SKEP III Home Office Support Site Visit Report

Consultant	Wahib Medanat Consultant Engineer	Rep No.	23-07092021
Contractor	Dijlah Establishment Constr. Contracting	Tender No.	(11/2019/USAID/SKEP/3/S) Schools for a Knowledge Economy Project (SKEP) - Phase (3) Package (1, 2)
Site Name	Jumana Bint Abit Taleb Basic Mixed School - Jerash	Day/ Date	Tue. 07/09/2021
Duration of Project	450 Calendar Days	Total Project Budget	8,314,983.735 JD

(Figure: 11)

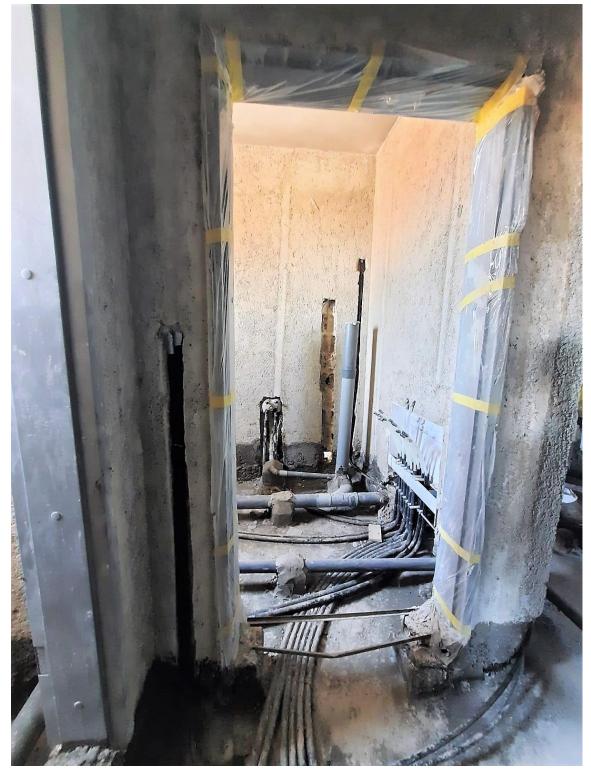
observed that one mechanical cabinet was installed in the wet area direct at the corner adjacent to door jamb. The cabinet should be removed inside by at least 20cm to allow for wall tile fixation and easy opening as stated on the approved workshop drawings.
